Re: Harbor Grove Submittal Review Comments

We have finished reviewing the Harbor Grove submittal package per your request, following are our review comments for your information, review, and distribution to the applicant.

- Civil Plan Set for Harbor Grove, prepared by The Blueline Group, dated 8/9/22.
- Storm Drainage Report for Harbor Grove, prepared by The Blueline Group, Date: May 3rd, 2022 and Revision Date: August 9th, 2022.
- Geotechnical Engineering Study for "Daffron Property", prepared by Earth Solutions NW, LLC, dated July 30, 2021 and Updated July 28, 2022.
- Groundwater Elevation Evaluation for "Proposed Development", prepared by Cobalt Geosciences, dated March 14, 2022.
- Stormwater Pollution Prevention Plan (SWPPP) for Harbor Grove, prepared by The Blueline Group, dated 08/09/2022.
- Revised Critical Area Reconnaissance Report for Sea Pac Homes, prepared by Wetland Resources, dated December 9, 2021.

SHEET NAME:
PS-01

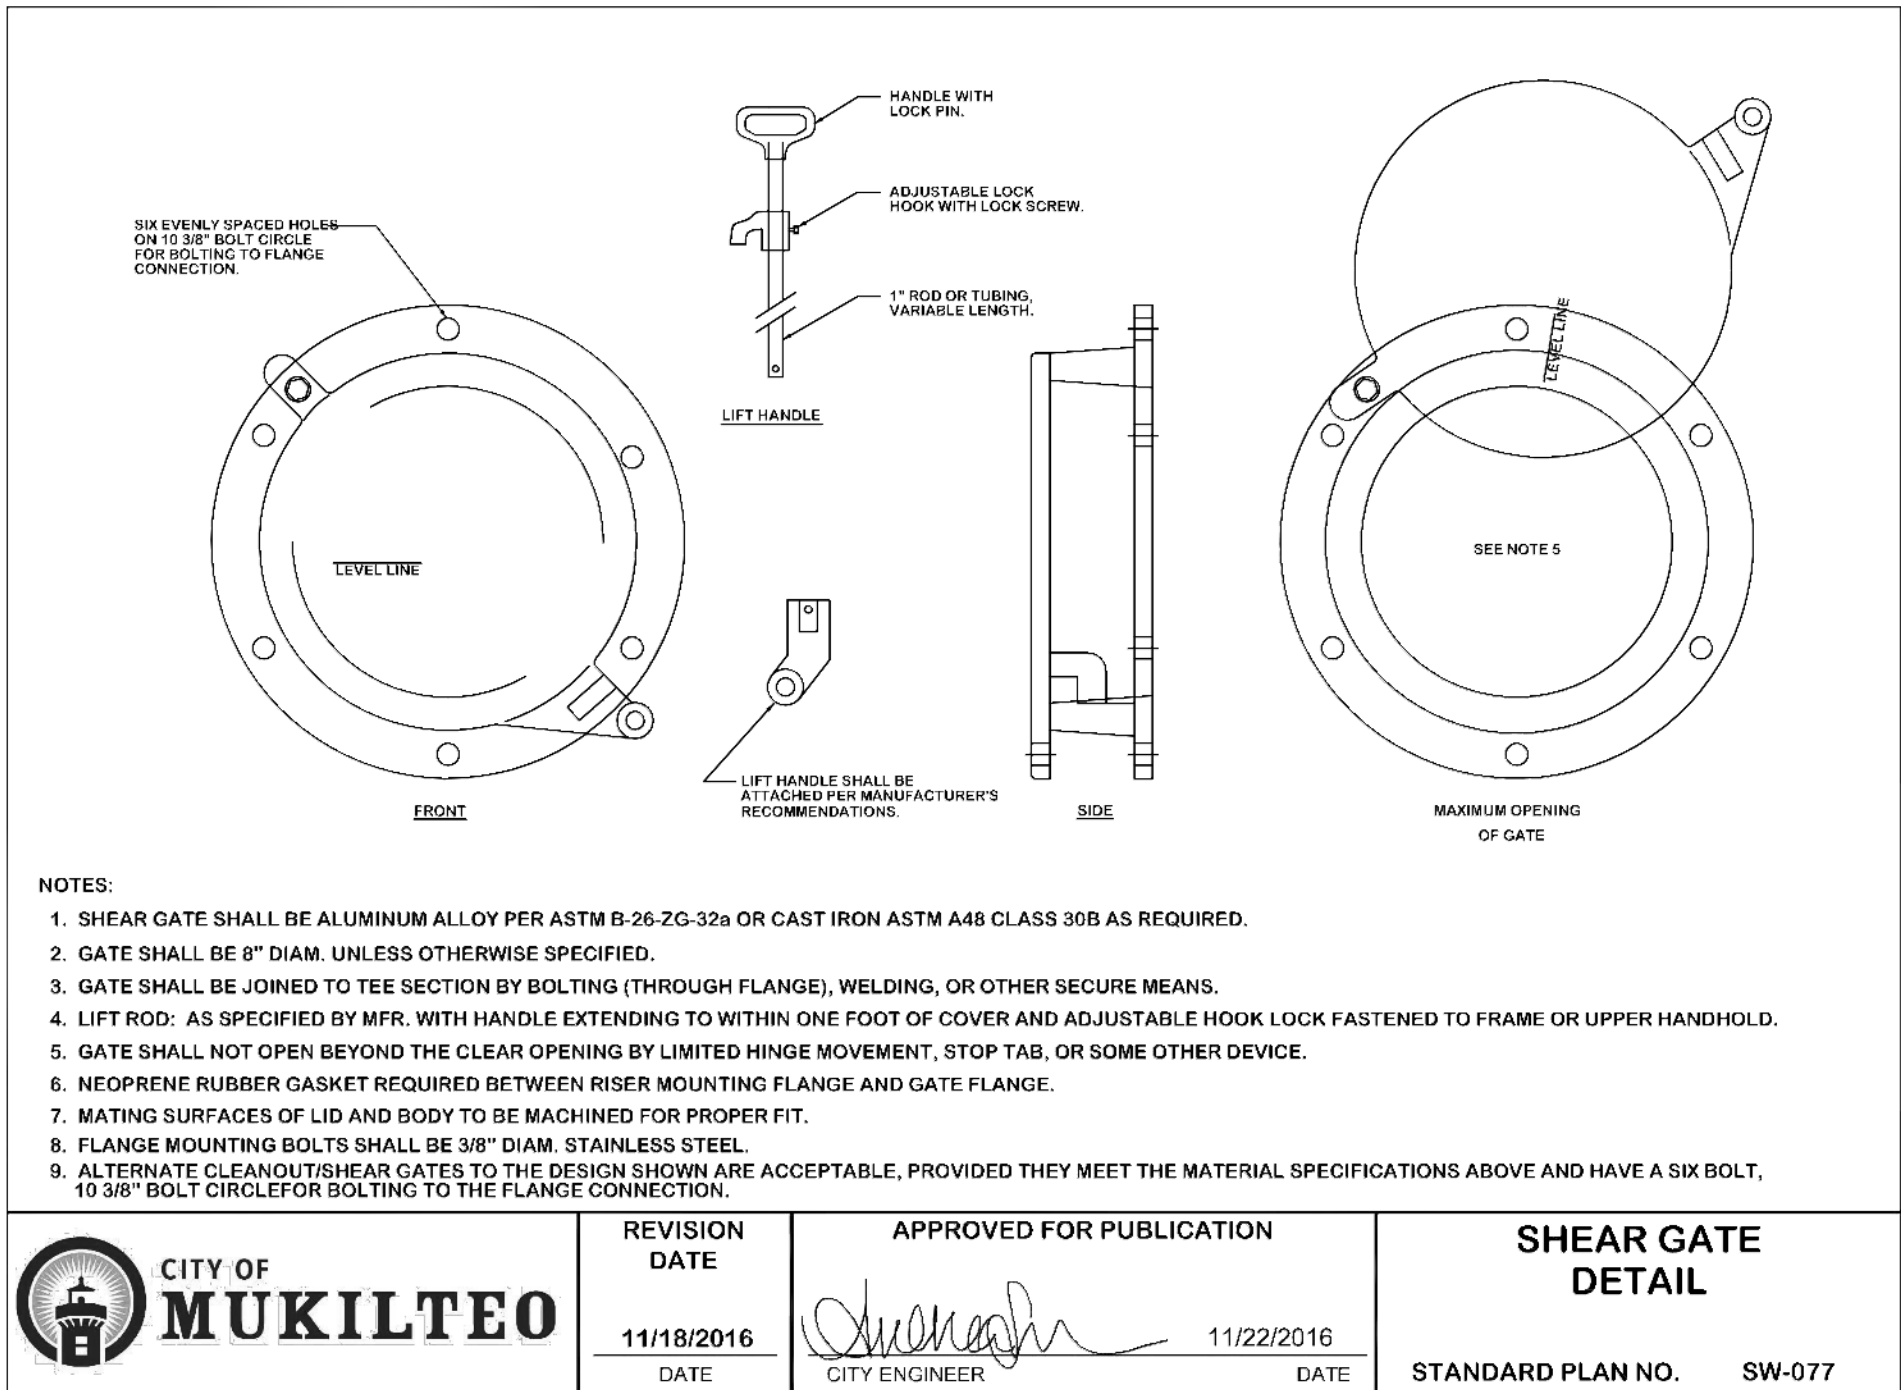
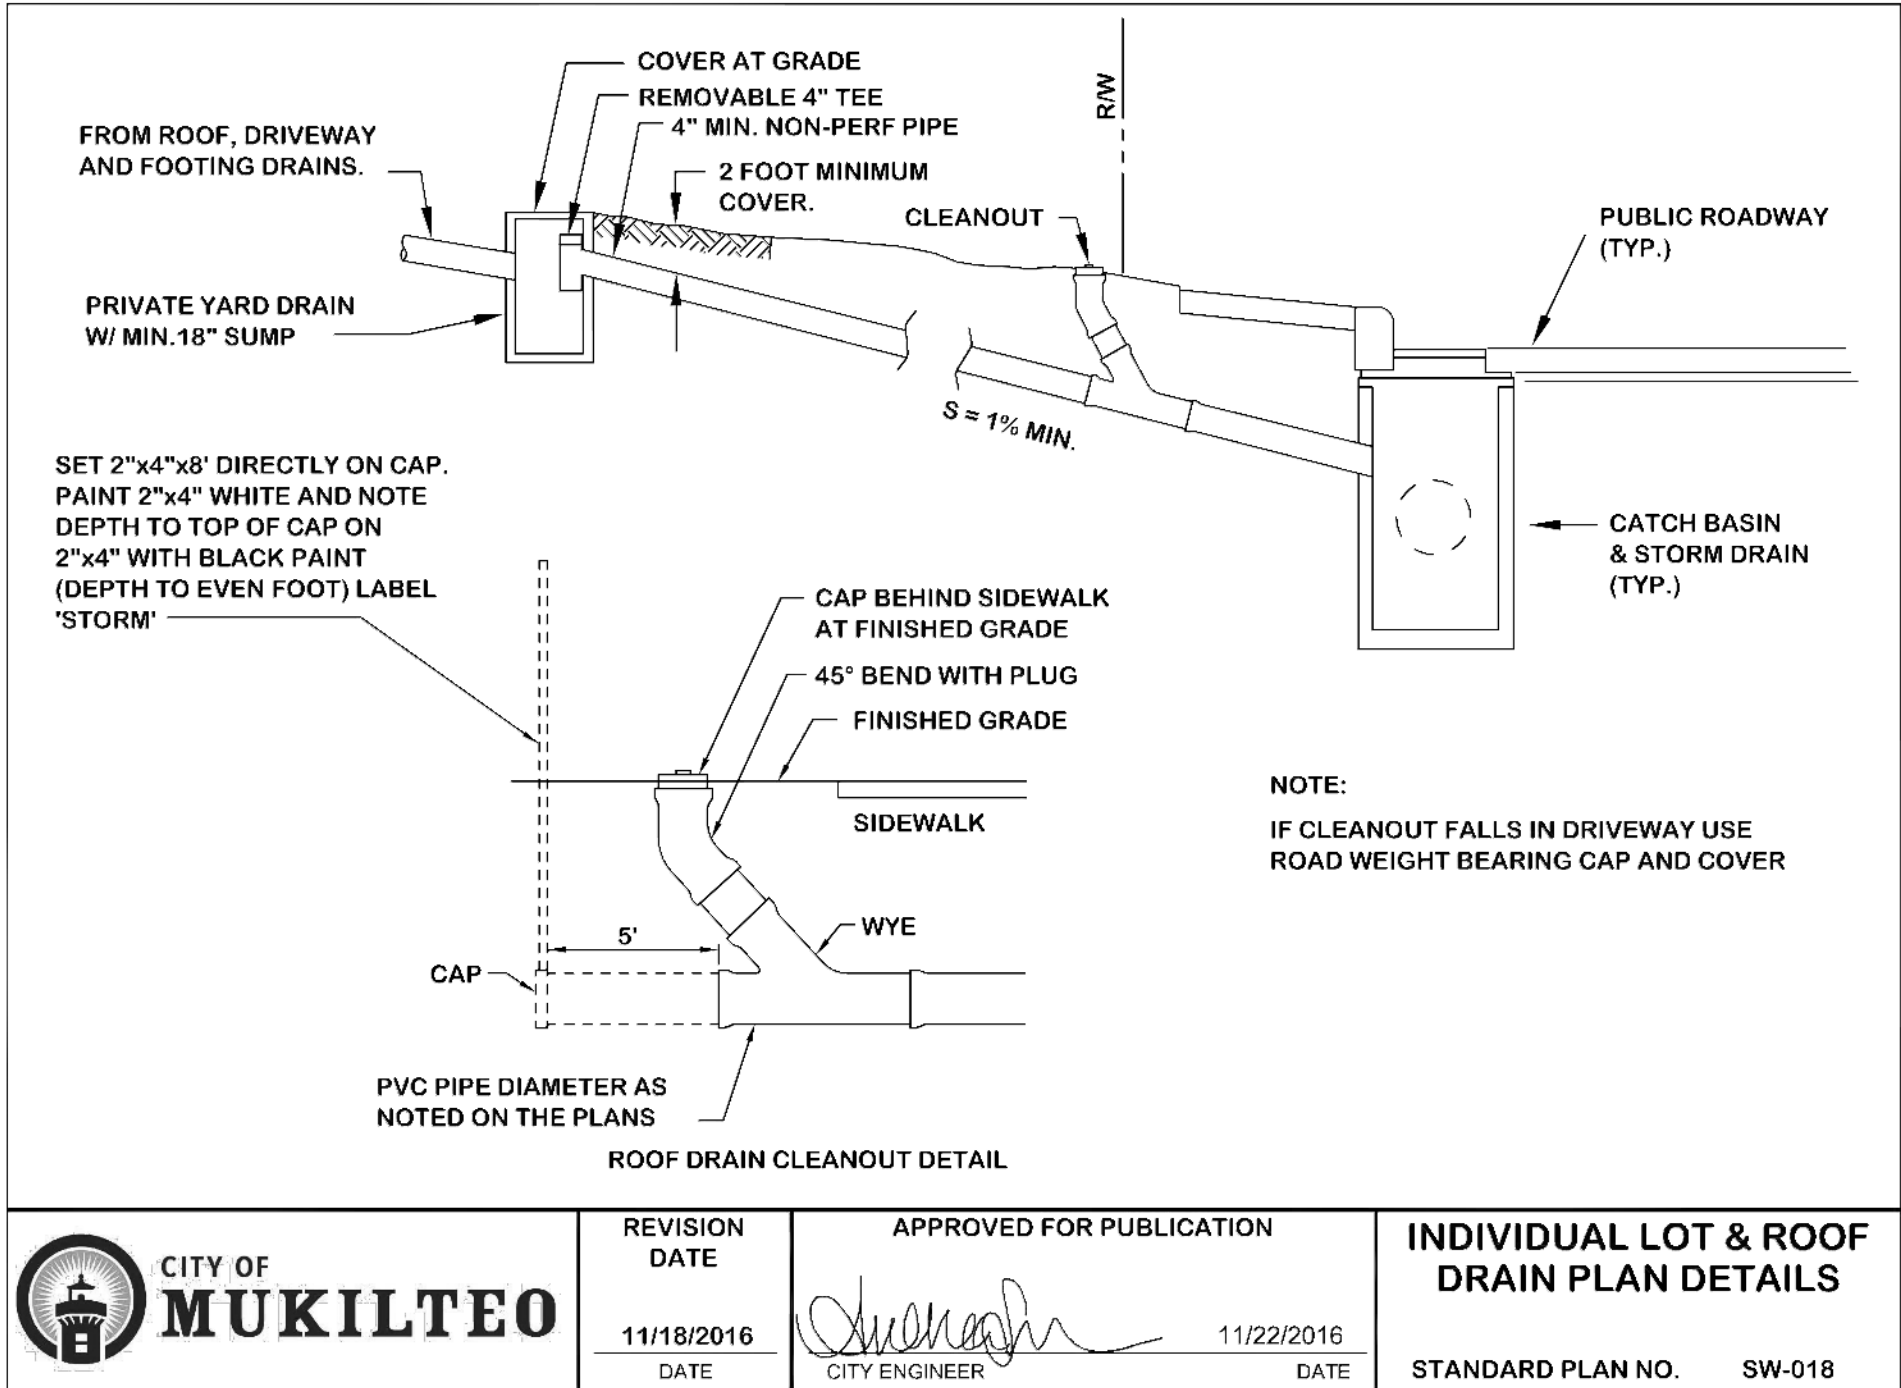
1. Applicant shall address the concerns expressed in the September 27, 2022 letter from Rugosa Ridge Homeowner's Association.

2. CB 9 detail shows “inlet from CB 9”. This should be “inlet from CB 10” from the pump structure.
3. Please address how the pump system is accessed for inspection and maintenance, and clearly note ownership/operation/maintenance responsibilities on this sheet.
4. Specify how the pump line can be serviced, repaired, or replaced under the walls when it becomes necessary.

Applicant shall address the concerns expressed in the September 27, 2022 letter from Rugosa Ridge Homeowner's Association.

Figure I-3.1: Flow Chart for Determining Requirements for New Development

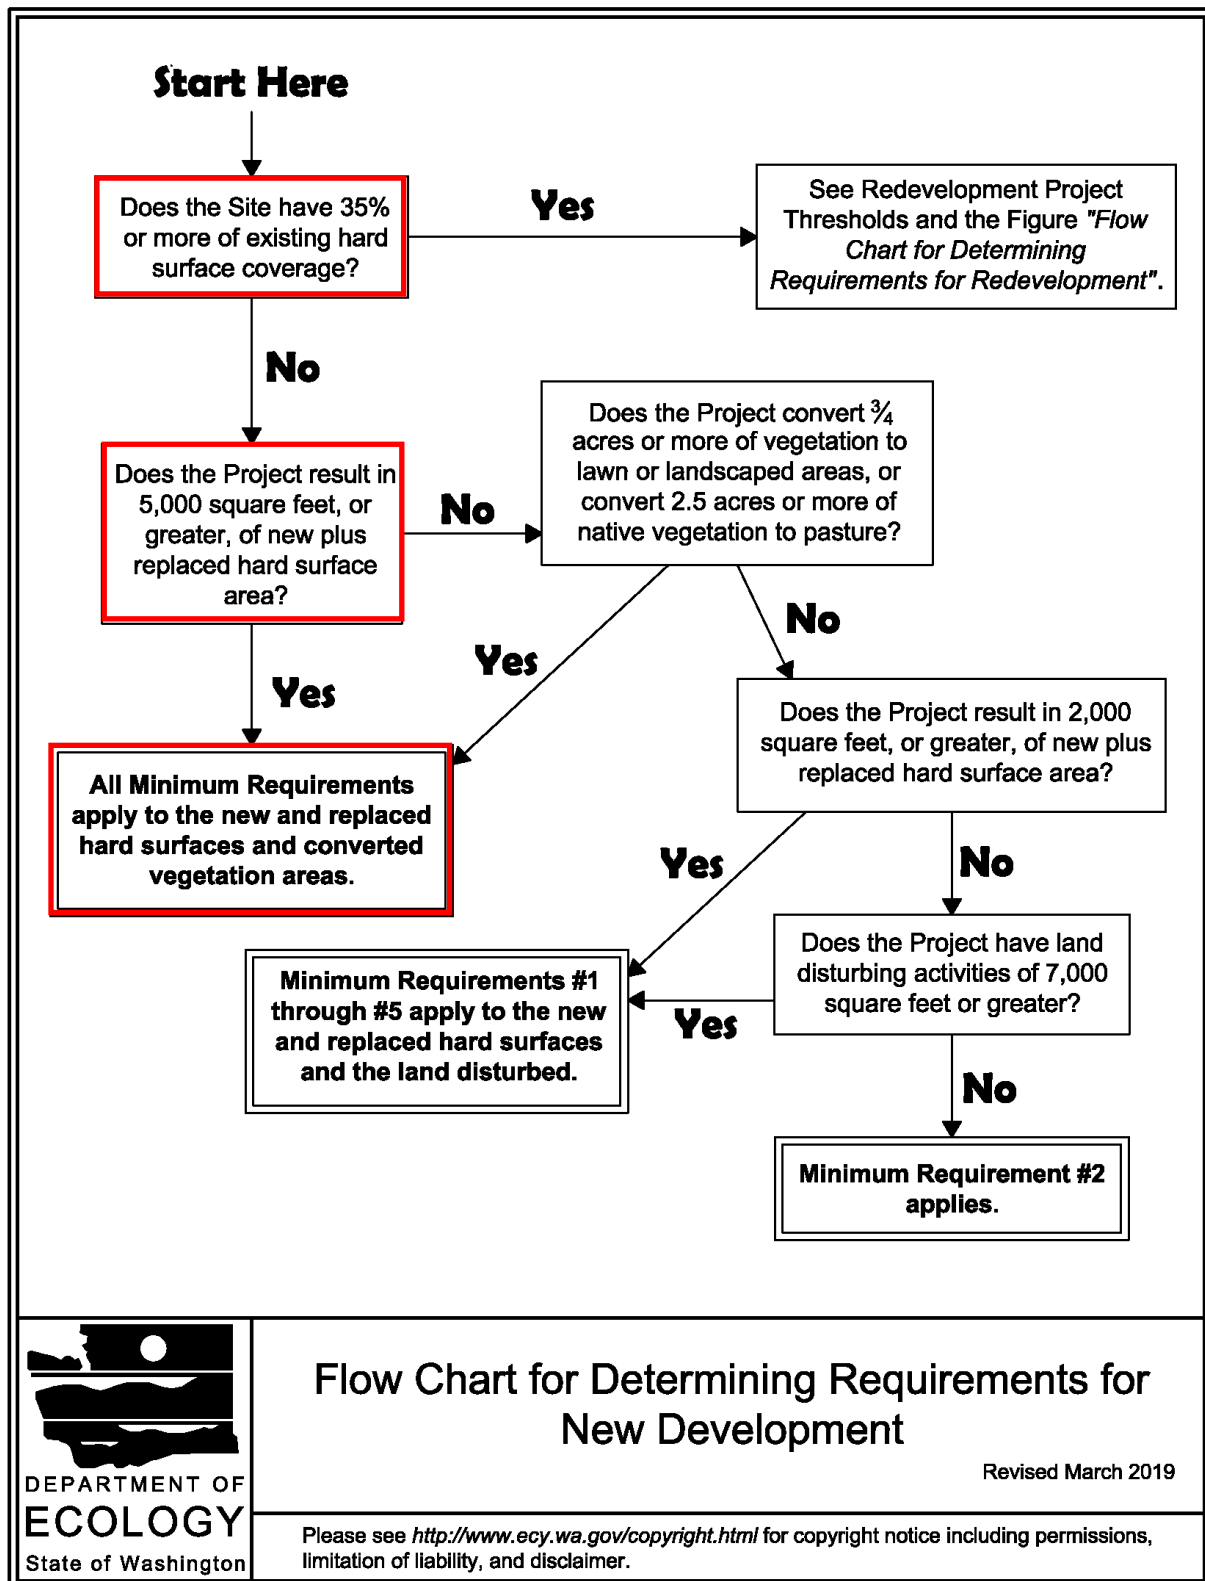
1. Update Manual version if necessary.

Figure I-3.3: Flow Chart for Determining MR #5 Requirements

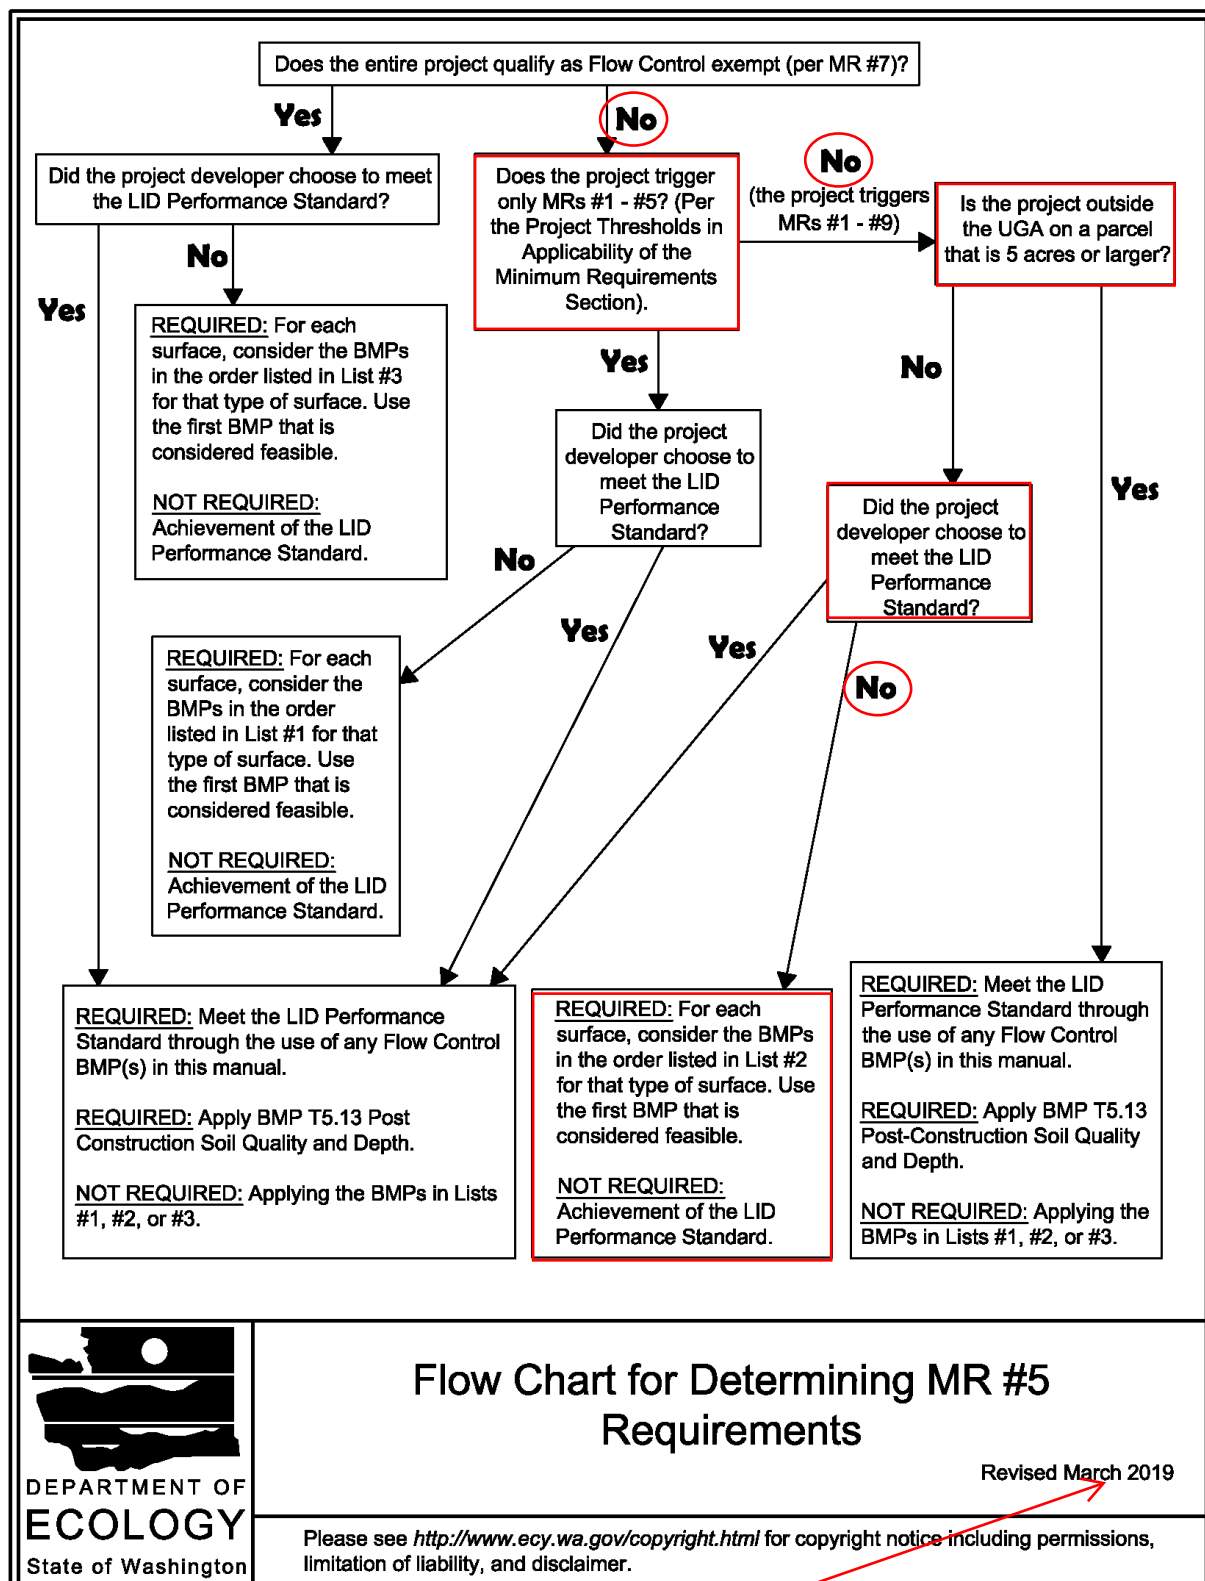
Use the 2014 manual version
